EXISISTING CONDITIONS SHEET

2135 SOUTH 17TH ST STREET
PHILADELPHIA, PA.

PLANS

A1

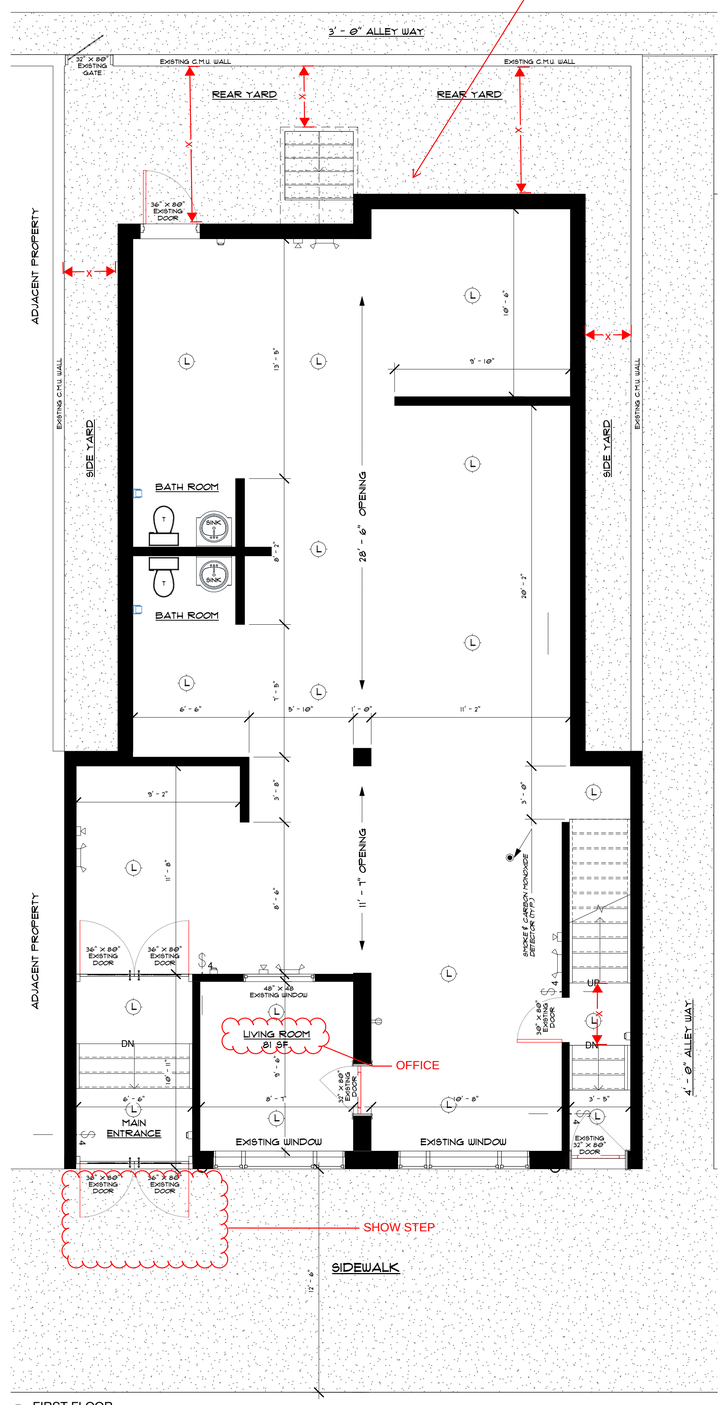
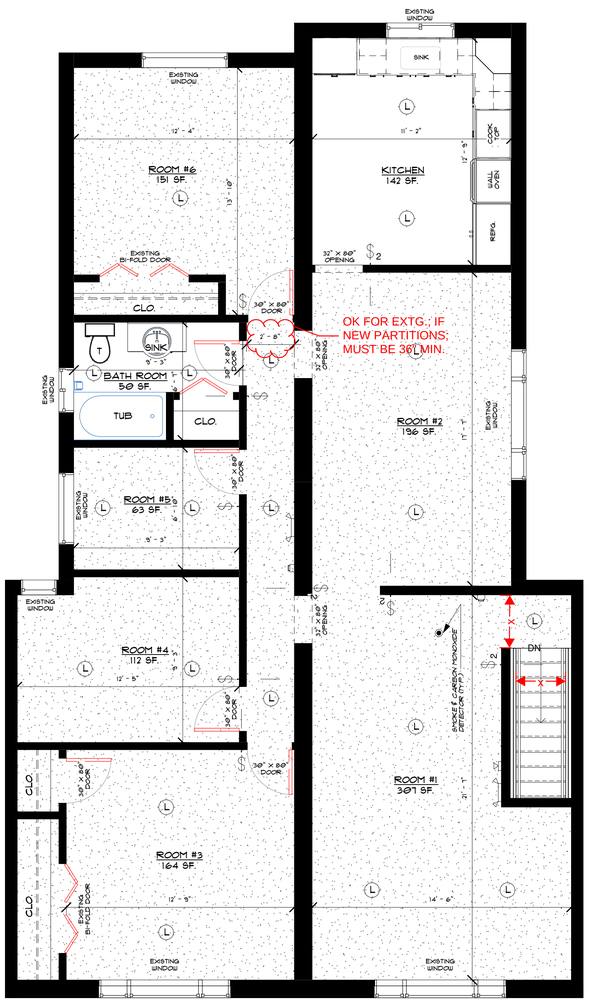
FRONT EGRESS IS NOT FULLY ACCESSIBLE AT THIS TIME.
BATHROOMS ARE NOT ADA ACCESSIBLE AT THIS TIME.
IF SPLIT USES, 1ST FLOOR CEILING MUST BE FIRE RATED FOR 1 HOUR, MINIMUM.
BLDG. DOES NOT HAVE SPRINKLERS

SHOW CONDENSER LAYOUT UNITS ON EXISTING PADS
